ROAD DESIGN MANUAL REVISIONS January, 2017

REINFORCED SOIL SLOPE (RSS) STANDARD

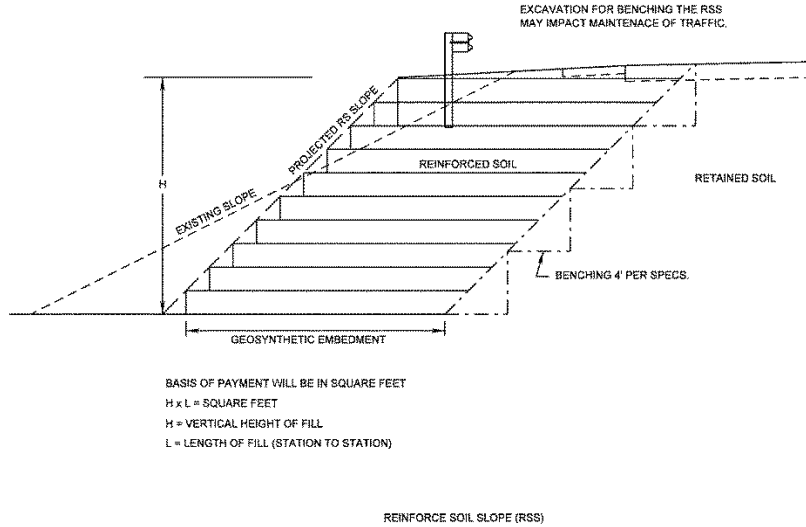
- Page 2E-21 thru 23 – Added the following language;
RETAINING STRUCTURES

RSS may be used as an alternative to purchasing additional right of way or the construction of a retaining wall. In general, RSS may be less expensive when a wall or additional right of way would otherwise be necessary.

This standard design is applicable when slopes are designed to be steeper than 2.0H:1.0V but no steeper than 0.5H:1.0V, and when the foundation conditions and backfill meets the criteria in the standard. Aesthetics and maintenance should be considered as part of the decision.

- 1) *In plan view, the top of slope and toe of slope.*
- 2) *Slope:*
 - *1/2H:1V*
 - *1H:1V*
 - *1½H:1V*
- 3) *Backfill Type:*
 - *A (Select Material)*
 - *B (On-site or Imported Soils)*

- 4) *Case:*
- 1 (Soft soil and maximum groundwater level at depths equal to or greater than slope height)
 - 2 (Soft soil at depths equal to or greater than reinforcement length and maximum groundwater level at toe of slope)

The maximum height for the RSS shall be 35 feet for Type A and 20 feet for Type B.
